CITY PLANNING COMMISSION

- APPLICATION:
- A. Negative Declaration
 - B. Tentative map to divide 4.11+ partially developed acres into 21 lot standard single family subdivision to be call Pinedale Park in the Standard Single Family (R-1) zone.

LOCATION: 1100 Pinedale Avenue

PINEDALE PARK

TENTATIVE SUBDIVISION MAP

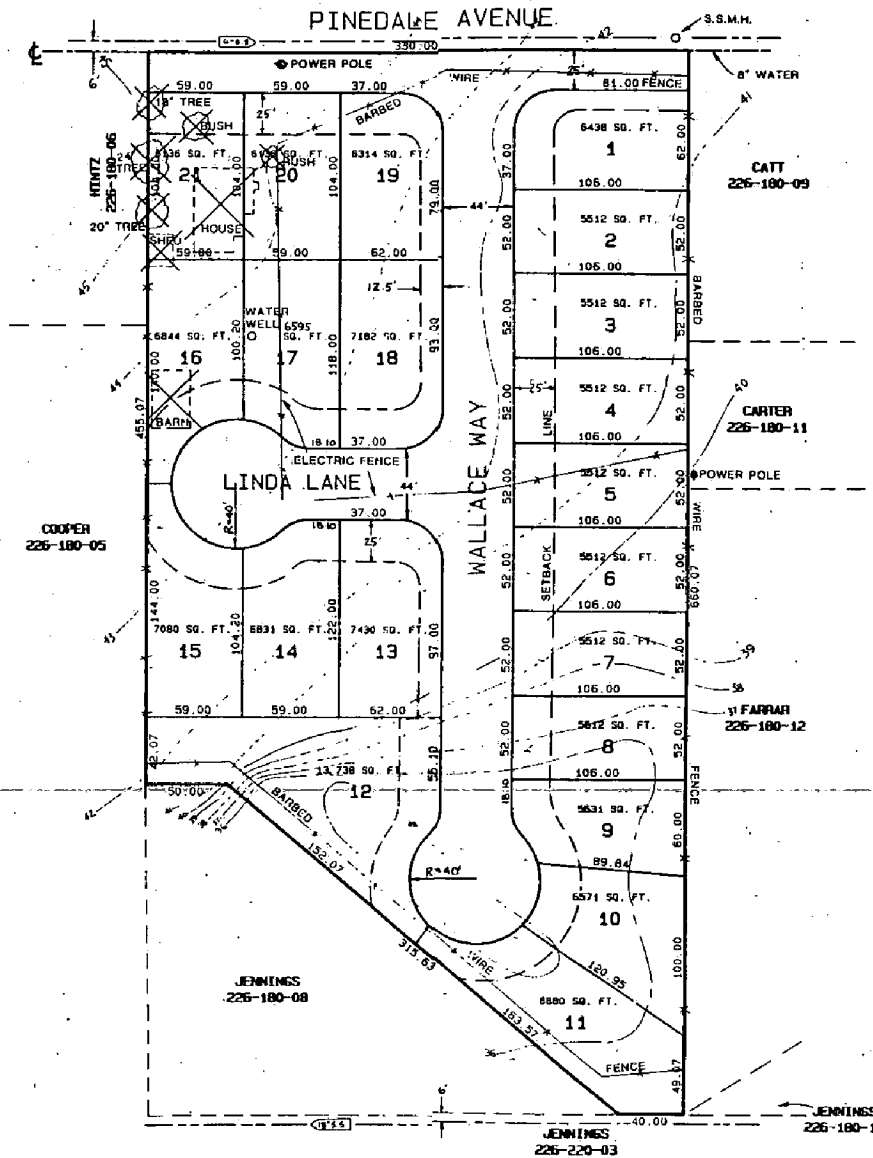
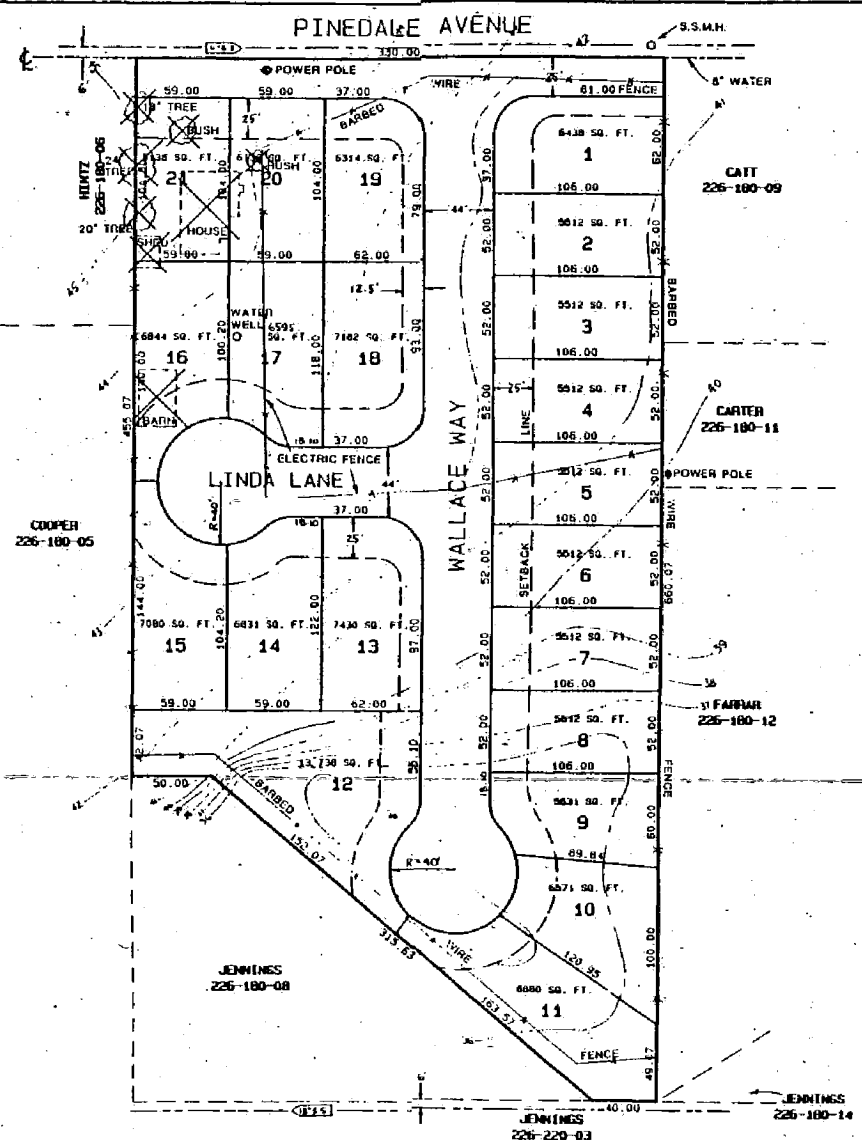
Based upon review by the Subdivision Review Committee, the applicant's site plan and map layout is acceptable. However, downstream and upstream channel improvements to Magpie Creek may be required. Full channel improvements adjacent to the subdivision and necessary improvements to the downstream channel to the location where existing improvements end are required. Improvements may be coordinated with the Tahoma Robla Subdivision (P87-108) under design between Rio Linda Boulevard and Marysville Boulevard. Storm drainage facility improvements may provide a significant cost to the subdivision of the project site.

40.811 of the City Code; including a 25 foot half-section on Southside of Pinedale Avenue and 15 ft. of paving westbound on Pinedale Avenue.

12. Right-of-way and drainage study required for Magpie Creek down stream to existing improvements. Onsite and offsite dedication required. Provide full channel improvements adjacent to subdivision and necessary improvements to channel downstream to location where existing improvements end. Improvements may be coordinated with Tahoma Robla (P87-108) under design between Rio Linda Boulevard and Marysville Boulevard.
